Access Compliance Report

Public Rights-of-Way

(Curb Ramps)

Intersection ID: 11847	Main Street: N_TRYON_ST	Cross Street: W_9TH_ST	Location: W
ADA ID: B3A4BE052C57	Ramp Type: PerpDiag	Initial Pass/Fail: Fail	Overall Compliance: No
Severity Score: 12.5			
Codes/Mitigation Info/Possible Solution		Field Measurements/Component Compliance

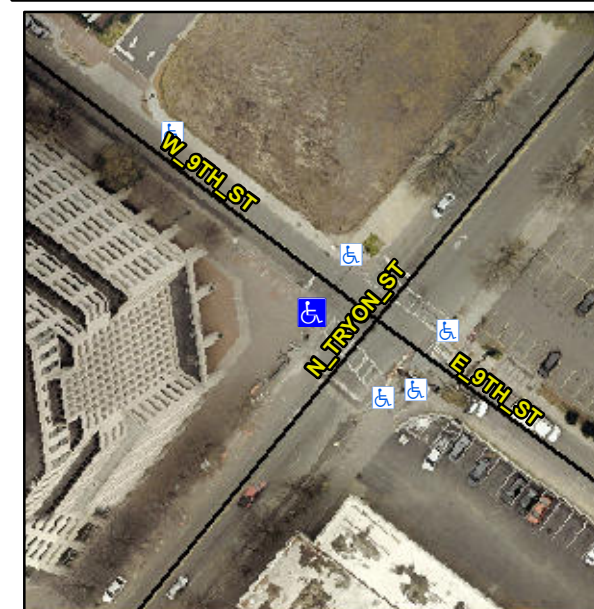
R304.2.2

Compliance	Description	Data	Compliance	Description	Data
N/A	Ramp Length (in)	96.0	No	Ramp Slope (%)	10.0
Yes	Ramp Width (in)	48.0	Yes	Ramp XSlope (%)	0.2
N/A	Flare Type LT	N/A	N/A	Flare Type RT	N/A
N/A	Flare Slope LT (%)	N/A	N/A	Flare Slope RT (%)	N/A
N/A	Flare Traversable LT?	N/A	N/A	Flare Traversable RT?	N/A
N/A	Landing Length (in)	N/A	N/A	DWS Provided?	N/A
N/A	Landing Width (in)	N/A	N/A	DWS Contrast?	N/A
N/A	Landing Slope (%)	N/A	N/A	DWS Length (in)	N/A
N/A	Landing X Slope (%)	N/A	N/A	DWS Full Width?	N/A
N/A	Landing Curb? (Y/N)	N/A	N/A	DWS Offset (in)	N/A
N/A	Shared Landing?	N/A			
N/A	Gutter Ponding?	N/A	N/A	Gutter Slope (%)	N/A
N/A	Gutter Lip Ht (in)	N/A	N/A	Gutter X Slope (%)	N/A
N/A	Painted X Walk1?	Yes	N/A	Painted X Walk2?	Yes
	X Walk 1 Direction	To SE		X Walk 2 Direction	To NE
N/A	X Walk 1 Width (in)	103.0	N/A	X Walk 2 Width (in)	106.0
	X Walk 1 Slope (%)	6.2		X Walk 2 Slope (%)	8.1
	X Walk 1 X Slope (%)	3.4		X Walk 2 X Slope (%)	0.4

Remove & Replace Curb Ramp With Two New Directional Ramps or Equivalent.
